INVITATION TO BID
BID NO. 9934
TROY SCHOOL DISTRICT 2022 PAVING PROGRAM

This Addendum is issued as modifications to the RFP previously issued to provide clarifications to the scope of work. This Addendum supersedes the original RFP. This along with the RFP becomes the bid documents.

1. For questions e-mail purchasingoffice@troy.k12.mi.us or through Buildingconnected.com.
2. Addendum #1 dated January 18, 2022 as prepared by PEA Group. (Attached)
3. Revise Bid Package, Proposal Form. Revise PF-2. Add Alternate #2 for Facilities and Operations Building. (Attached)
4. Pre-Bid Meeting Sign In Sheet dated January 18, 2022. (Attached)

C-4.1

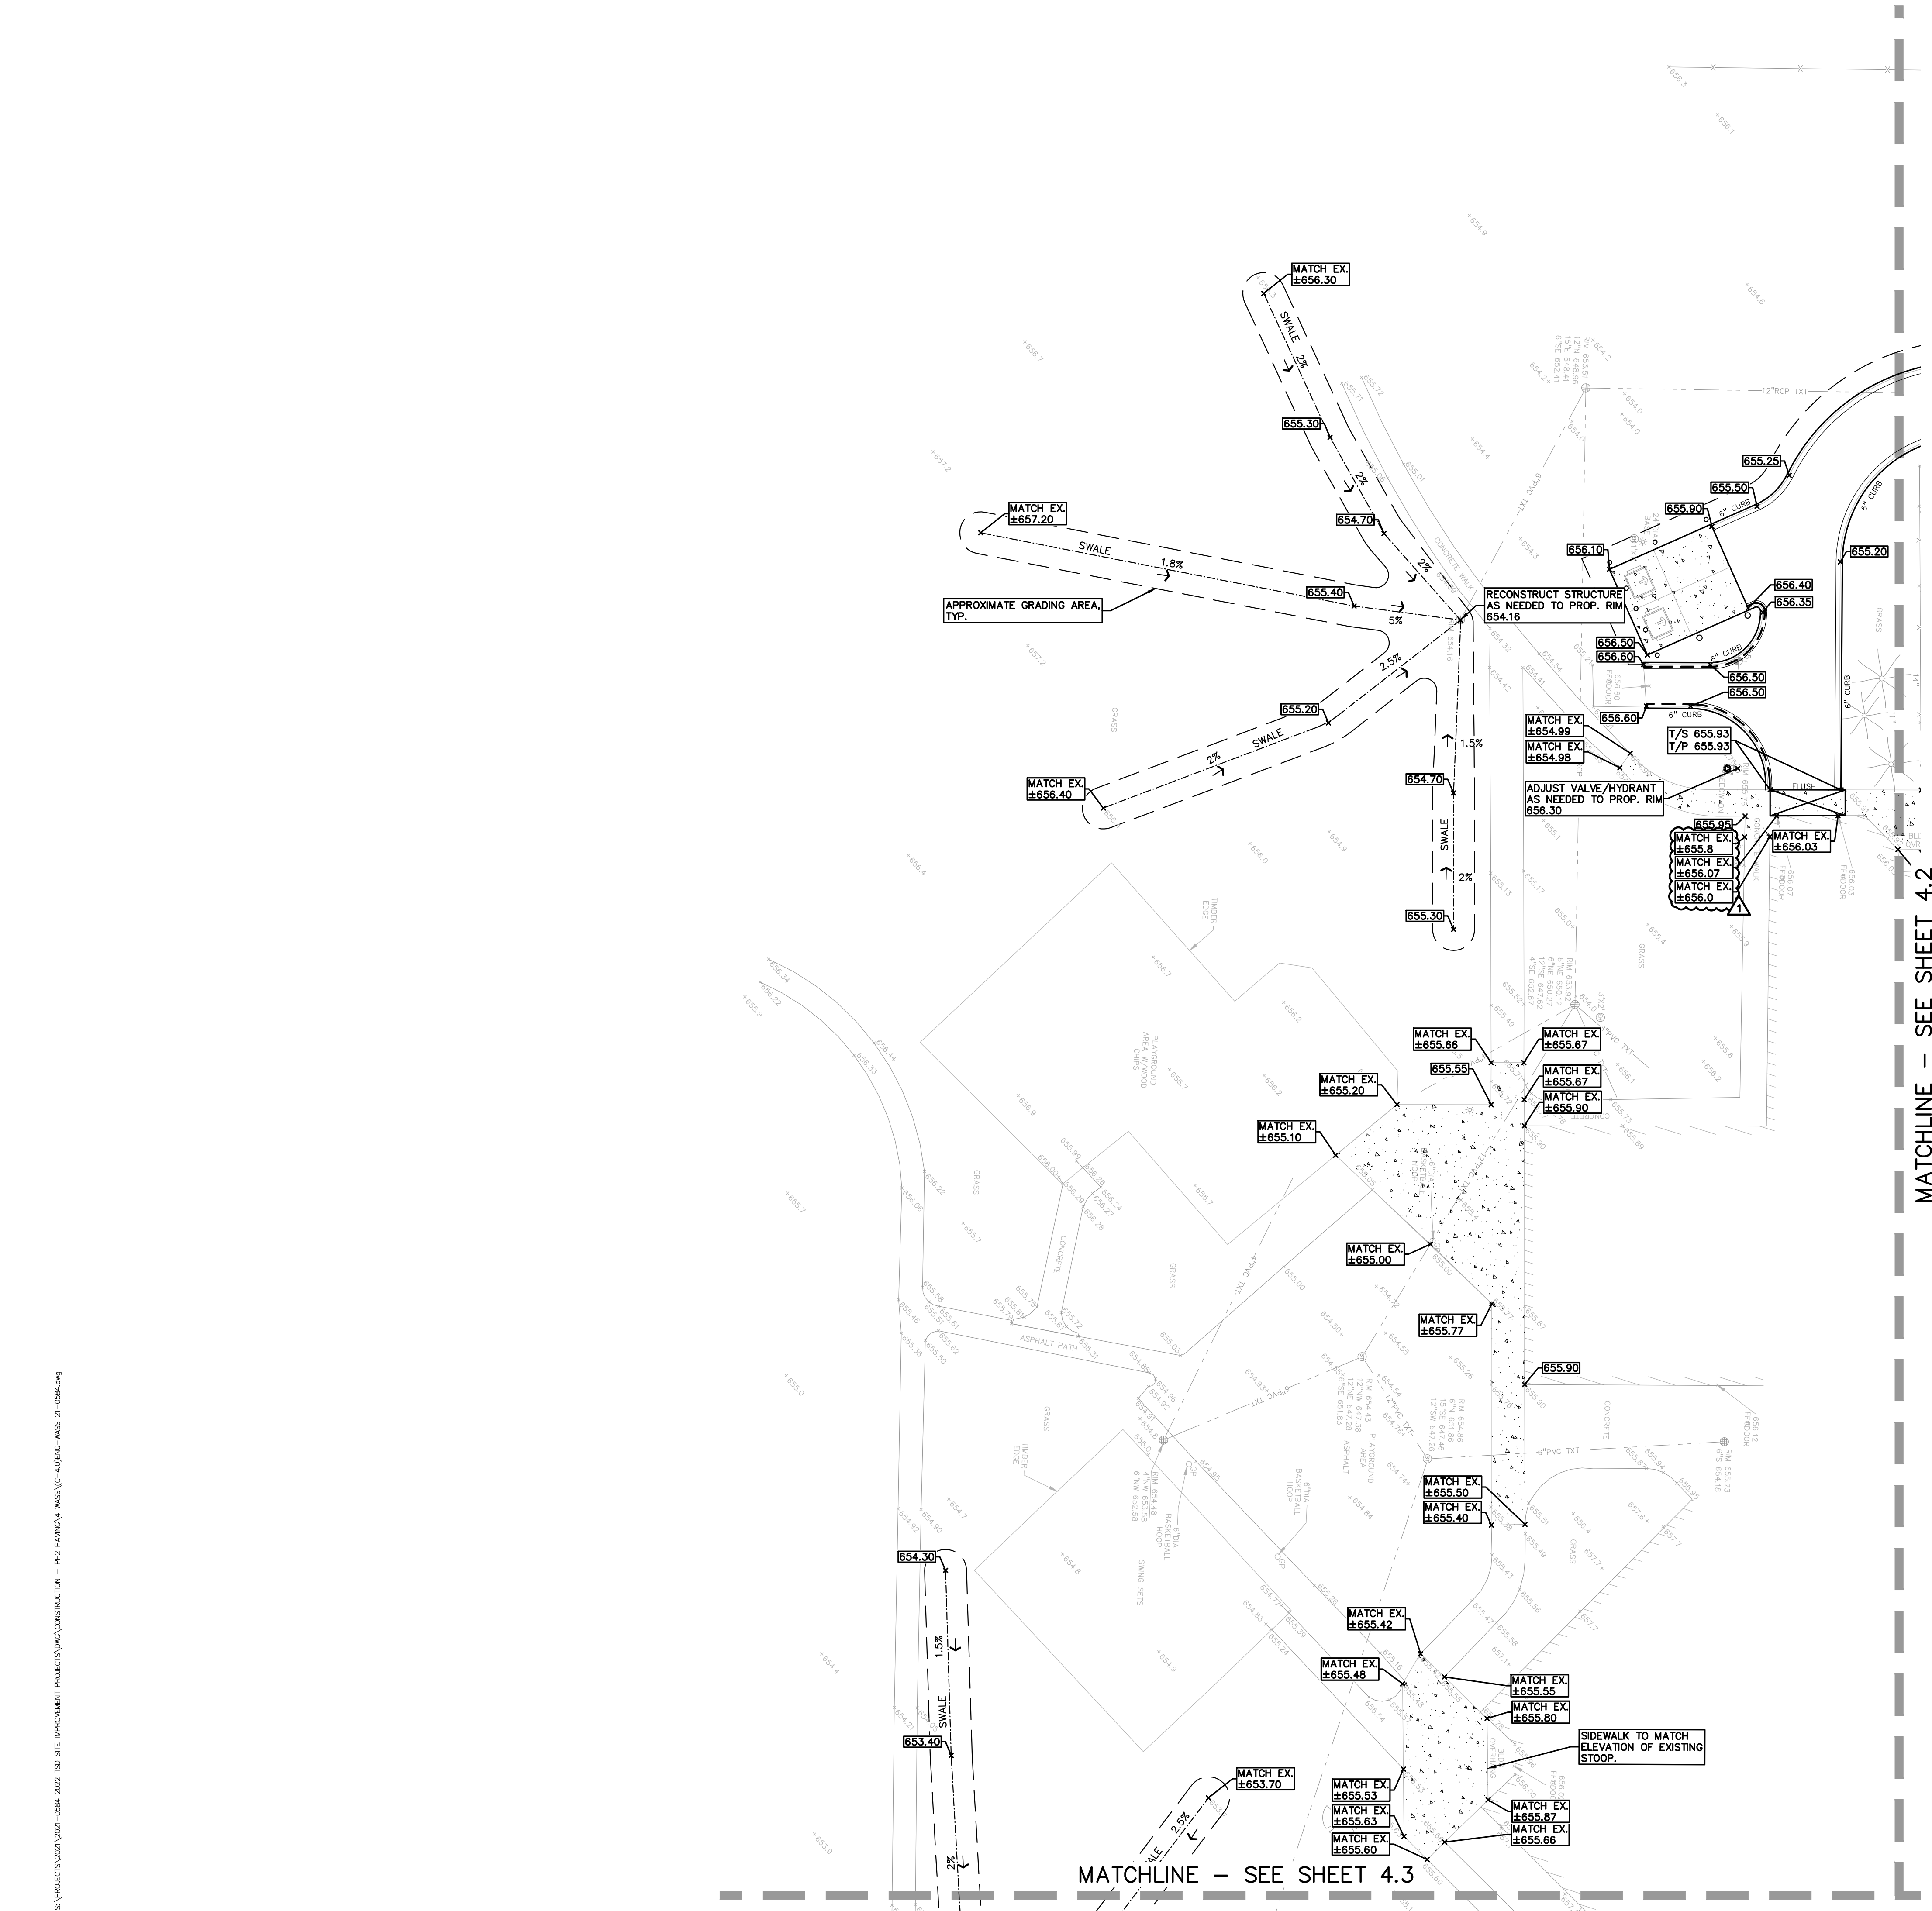
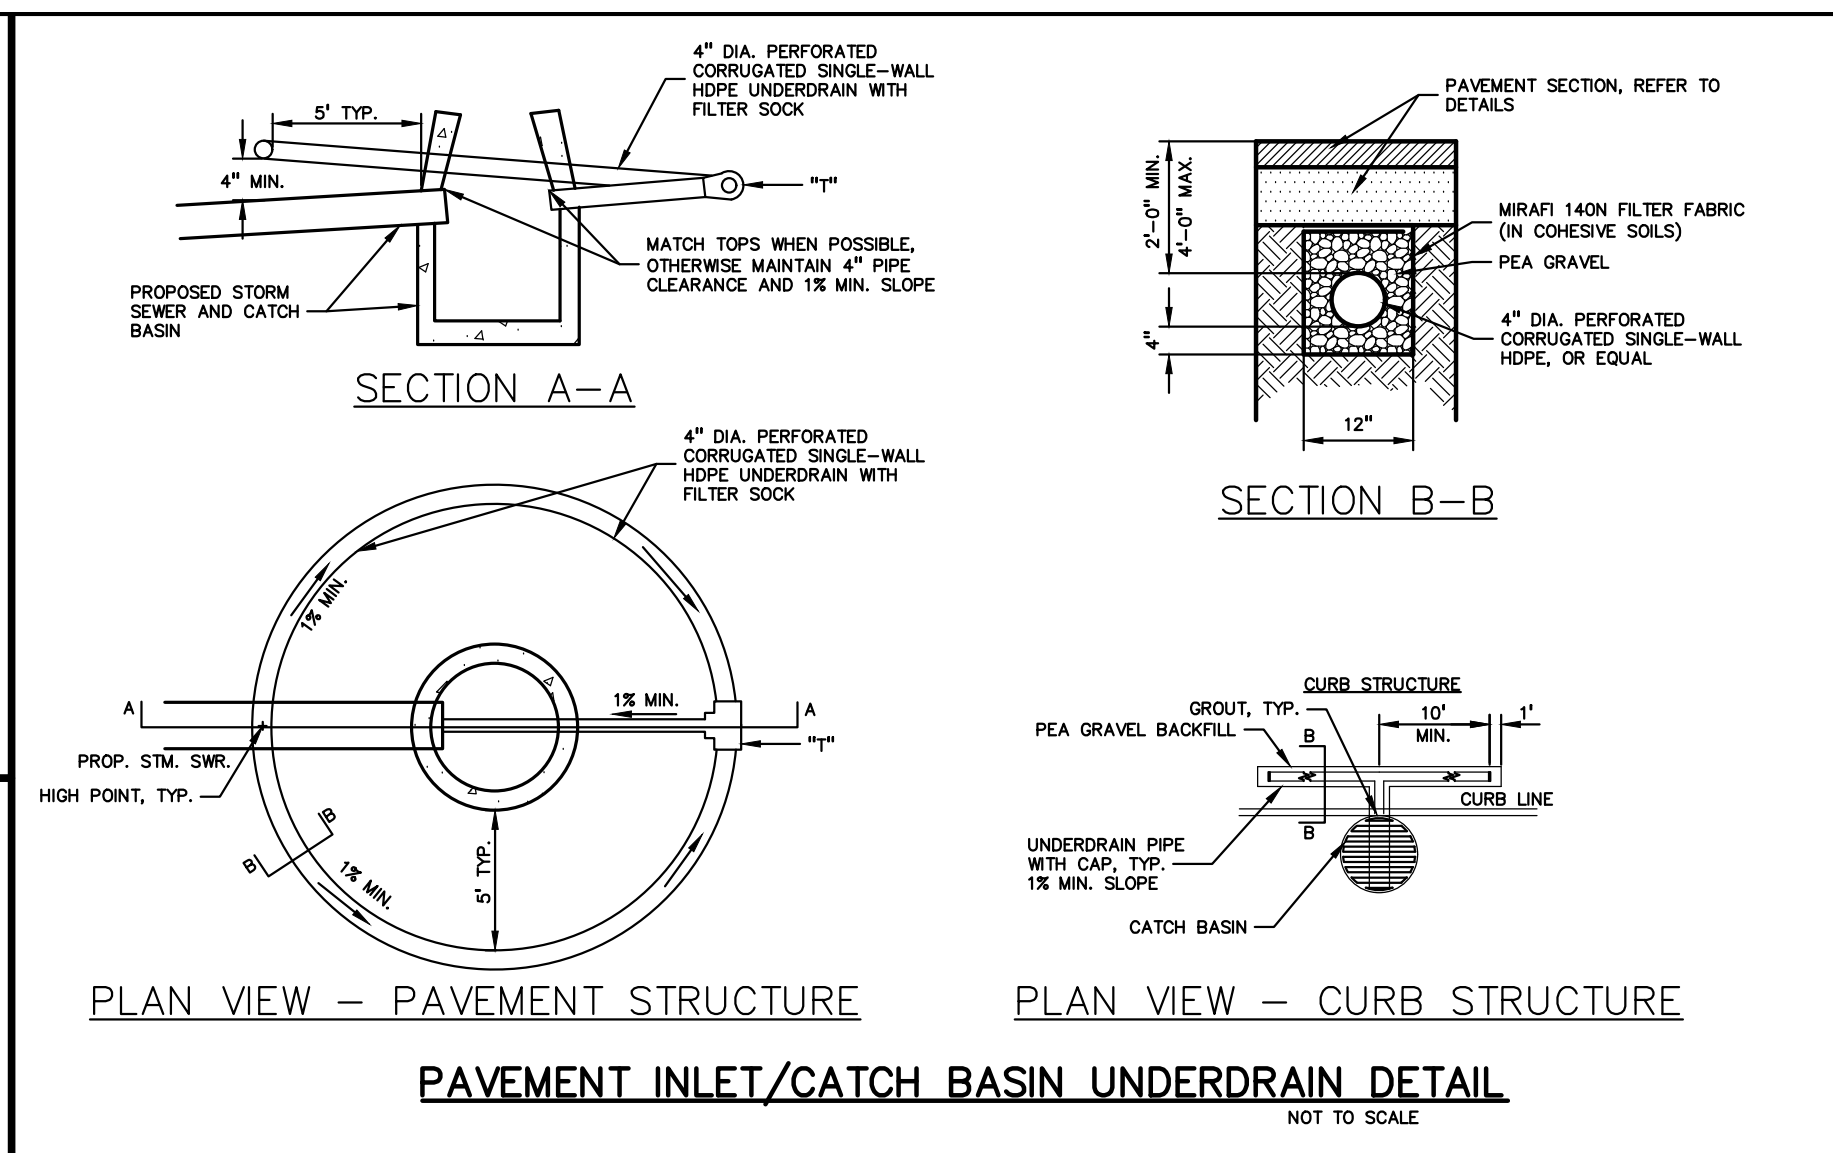
- e. Sheet C-4.1
 - 1. Grades were updated to reflect the change in the area of sidewalk replacement along the south side of the northwest corner of the building.
